February 10, 2017

Subject: Fuel Leak Case No. RO0003098 and GeoTracker Global IDT10000004218, Ed's Liquor Store, 2700 23<sup>rd</sup> Avenue, Oakland, CA 94606-3530

Alameda County Department of Environmental Health (ACDEH) has reviewed the December 2, 2016 *Low Threat Case Closure Request* (RFC) prepared on Chevron's behalf by GHD for the referenced case. ACDEH has evaluated the data in conjunction with the case files and the State Water Resources Control Board's (SWRCBs) Low Threat Underground Storage Tank Case Closure Policy (LTCP) general and media specific criteria. Based on ACDEH staff review, we have determined that the site does not meet the following criteria, and consequently, ACDEH must deny closure:

Figure 2  
 SITE PLAN  
 FORMER TEXACO STATION 359766 (ED'S LIQUORS)  
 2700 23RD AVENUE  
 Oakland, California

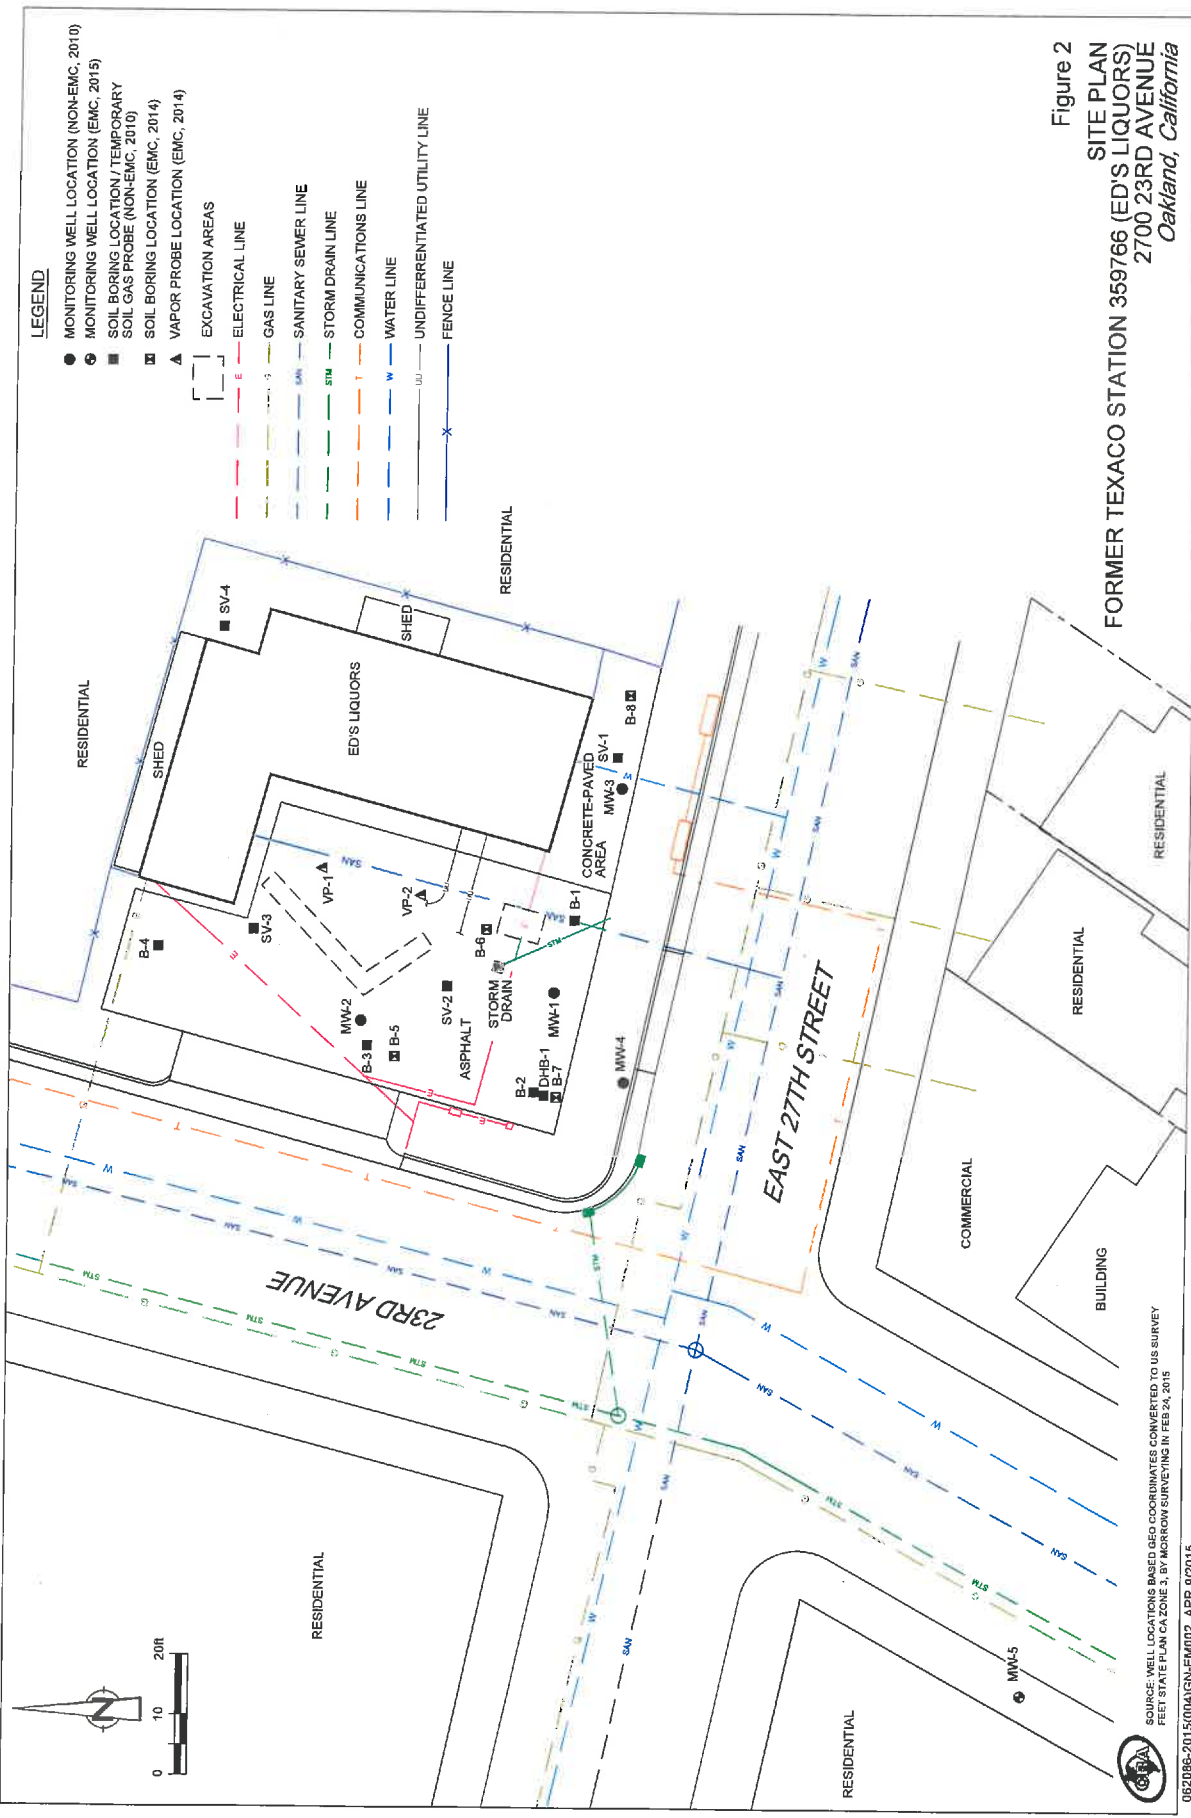
**ADCEH's Response:** ACDEH's review of the case files indicates that insufficient data and analysis has been presented to assess compliance with Media Specific Criteria for Groundwater. The RFC concludes that groundwater flow direction is to the southwest and has been defined by downgradient monitoring well MW-5. Samples collected from monitoring well MW-5 have consistently been non-detect and thus GHD concludes the contaminant plume has been defined. However, the *Subsurface Investigation Report and Conceptual Site Model* dated August 29, 2014 prepared by Conestoga-Rovers & Associated (CRA) on behalf of Chevron stated that the sewer and storm drain lines in E. 27<sup>th</sup> Street and 23<sup>rd</sup> Avenue (bounding the subject site on the south and west side respectively), may come in contact with groundwater. CRA also concludes that it is uncertain whether these lines act as preferential pathways for hydrocarbon migration. ACDEH concurs with the CRA assessment that if the sewer and storm drain lines are in contact with groundwater, these lines may act as preferential pathways for hydrocarbon migration off site to the residential and commercial properties across E. 27<sup>th</sup> Street. Please refer to the groundwater gradient utility survey figures included in Attachment A to this letter.

Therefore, please present a strategy in the Data Gap Work Plan to evaluate the extent of the contaminant plume including, but not limited to, groundwater monitoring and sampling of all five groundwater monitoring wells for TPHg, TPHd, TPHmo, benzene, toluene, ethylbenzene, and xylenes (BTEX), naphthalene, fuel oxygenates and collection of soil and grab groundwater samples
